# UNITED STATES PATENT AND TRADEMARK OFFICE

APPLICATION NO.	FILING DATE	FIRST NAMED INVENTOR	ATTORNEY DOCKET NO.	CONFIRMATION NO.
10/804,401	03/18/2004	Robert W. Ratte	5844	7377
44341	7590	07/02/2007		
JACOBSON & JOHNSON ONE WEST WATER STREET, SUITE 285 ST. PAUL, MN 55107			EXAMINER ALEJANDRO, RAYMOND	
			ART UNIT 1745	PAPER NUMBER
			MAIL DATE 07/02/2007	DELIVERY MODE PAPER

**Office Action Summary**

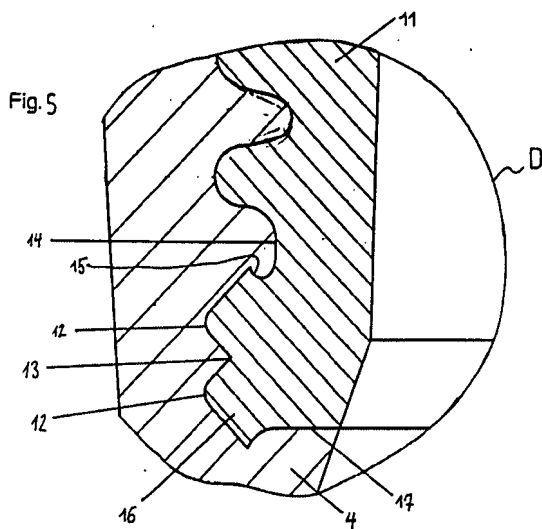
The EP'268 discloses terminal for batteries wherein the terminal includes continuous grooves (the acid rings) which can be inserted into a battery case (ABSTRACT/COL 1, lines 30-55). Specifically, **Figure 5** depicts grooves on the battery terminal having an acute angle, or angle less than 90°, or V-shaped groove (See reference numerals 42-43 below). The groove has at least two lips (see reference numerals 42).

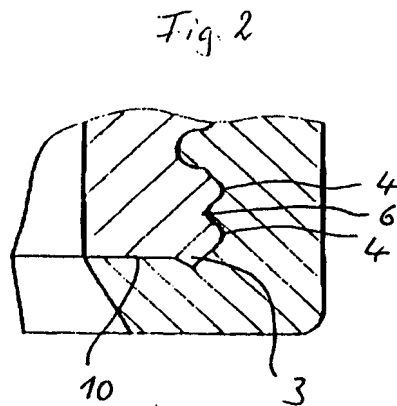
Specifically, **Figure 2** depicts grooves on the battery terminal having an acute angle; or angle less than 90°, or V-shaped groove (See reference numerals 4 and 6 below). The groove has at least two lips (see reference numerals 4).
